Puget Sound Energy ELCC Workshop

Energy & Environmental Economics ELCC Review

August 31, 2021

January 2027 Dispatch Plots: Week of 1/25

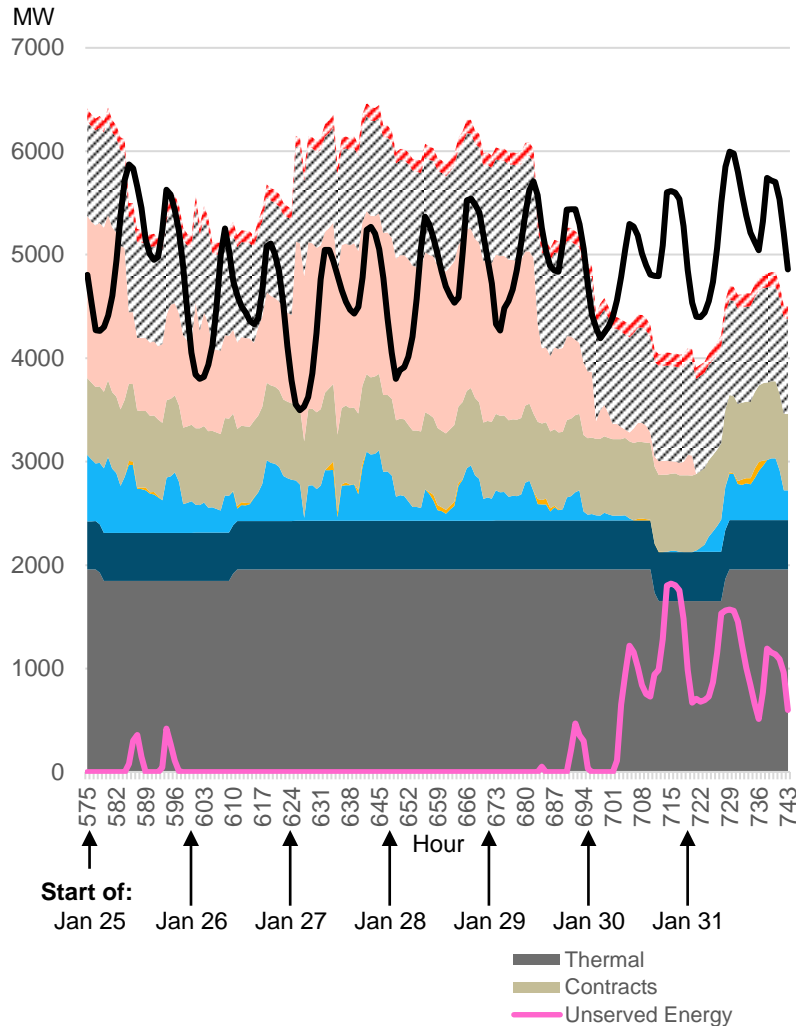
- + Modifying the PSE Base Case so Mid-C output is increased by 500 MW during unserved energy events does not reduce the duration of the 42-hour outage, illustrating the impact of Mid-C on the outage characteristics against which battery storage is tested**

- + Outage duration (continuous) = 42 hours
- + Maximum unserved energy = 1,821 MW
- + Minimum unserved energy = 110 MW (hour 702)
- + Mid-C output during outage = 61 MW (avg)

January 2027 Dispatch Plots: Week of 1/25 (cont'd)

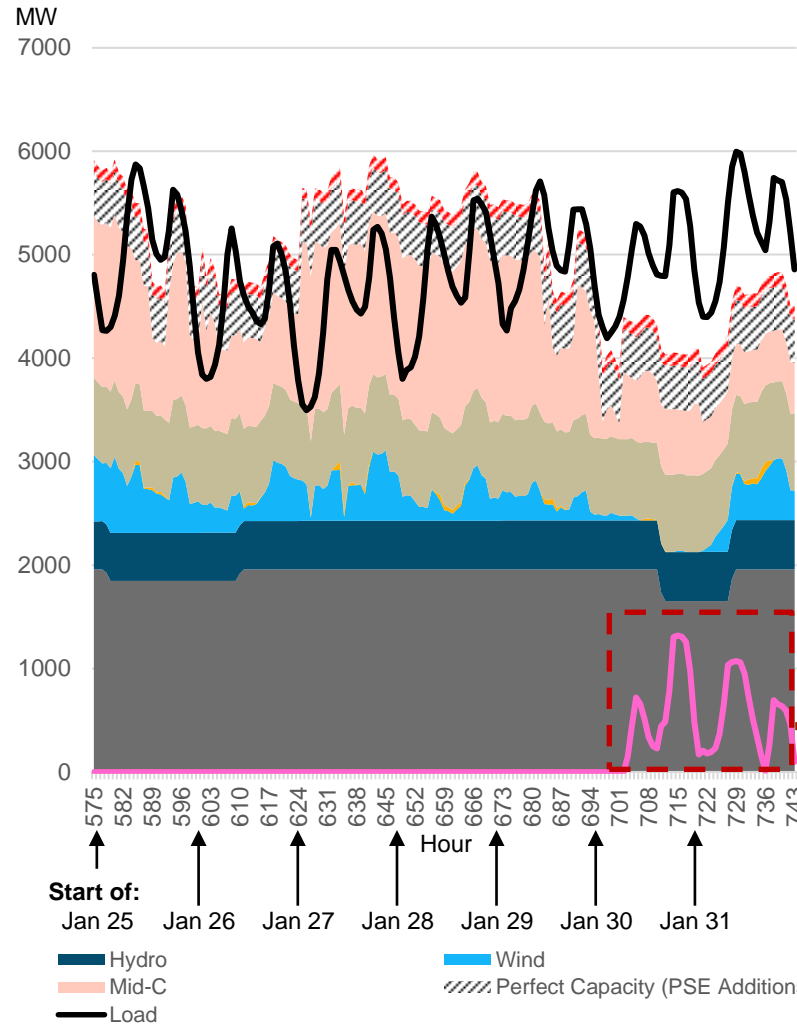
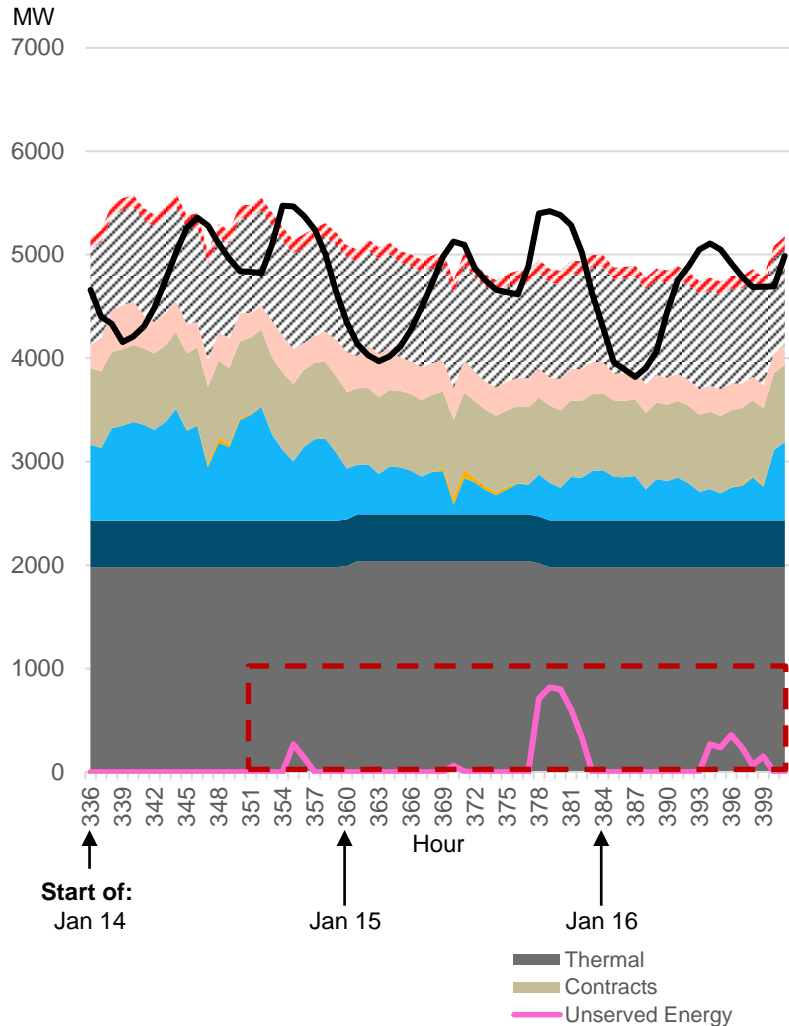
- E3 modified the PSE Base Case so that 500 MW of additional capacity is available from Mid-C during unserved energy events, reflecting PSE's share of illustrative regional capacity additions. In tandem, E3 reduced the perfect capacity additions assumed on the PSE system by 500 MW

- + Outage duration (continuous) = 41 hours
- + Maximum unserved energy = 1,321 MW
- + Minimum unserved energy = 13 MW (hour 736)
- + Mid-C output during outage = 561 MW (avg)

January 2027 Dispatch Plots: January 14-16 (cont'd)

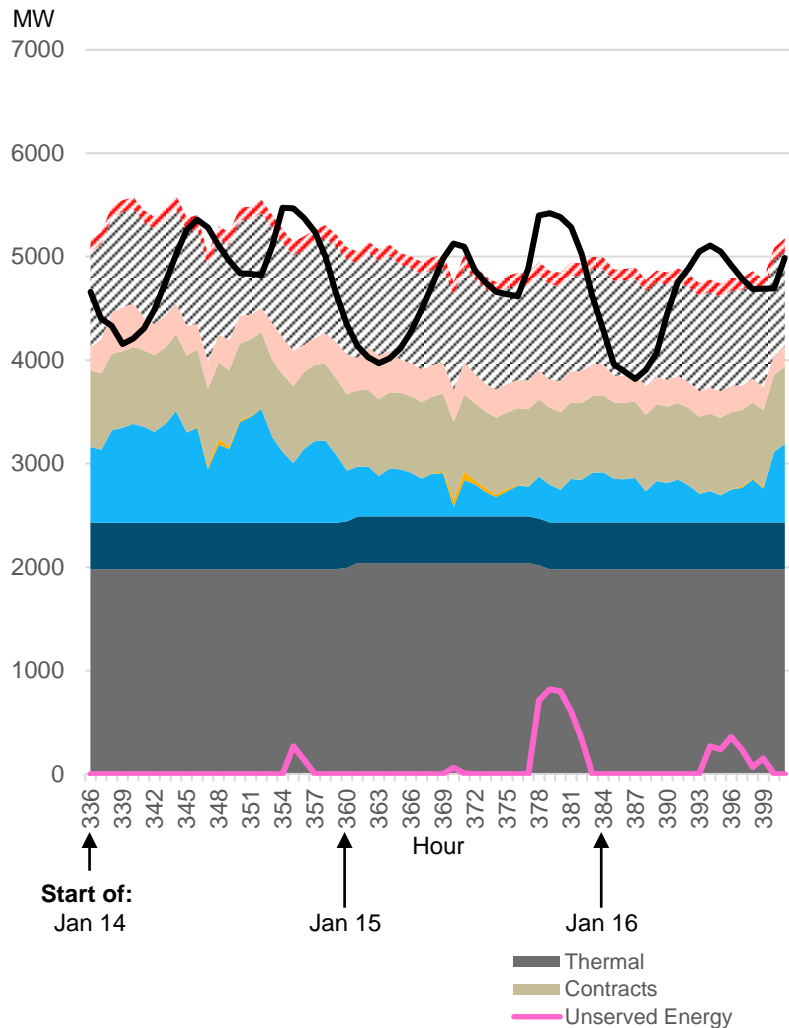
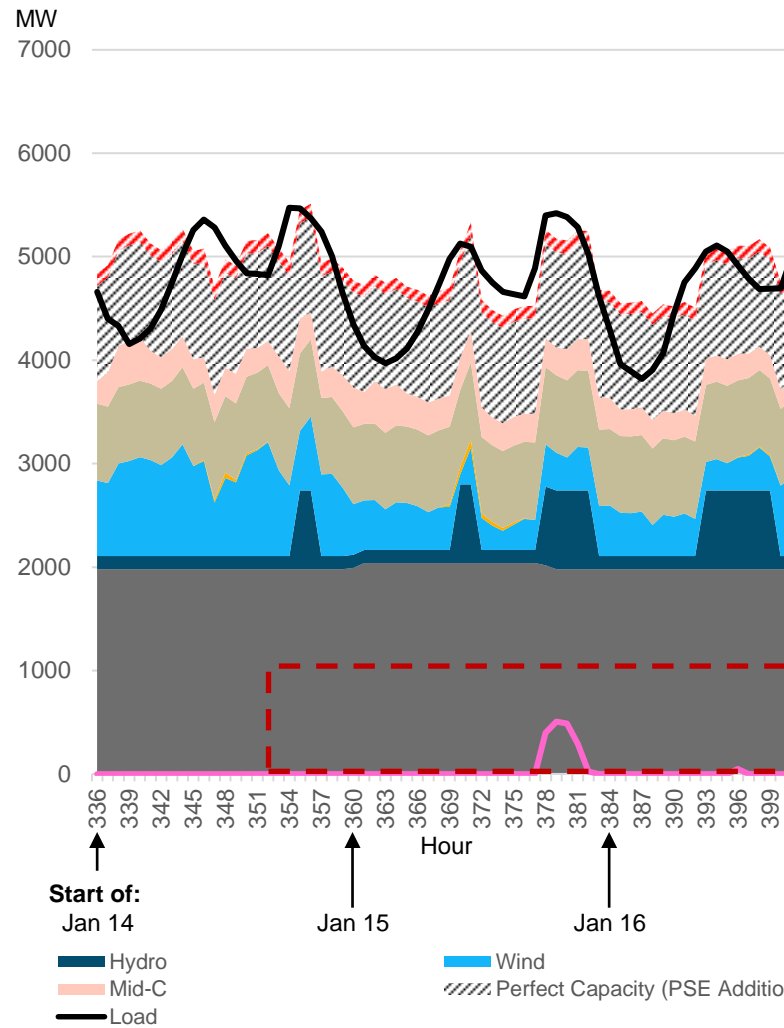
- PSE Base Case hydropower resources are modified to operate with energy limitations (50% capacity factor, pmin of 25%) and dispatch capabilities (i.e. output can be increased to pmax when there is unserved energy)

- + Modifying hydro resources so they are energy-limited and dispatchable illustrates the ability of hydro to meet unserved energy needs over shorter-duration periods (e.g. 4-6 hours)**

- + Outage duration (longest) = 5 hours
- + Maximum unserved energy = 507 MW
- + Minimum unserved energy = 25 MW (hour 382)
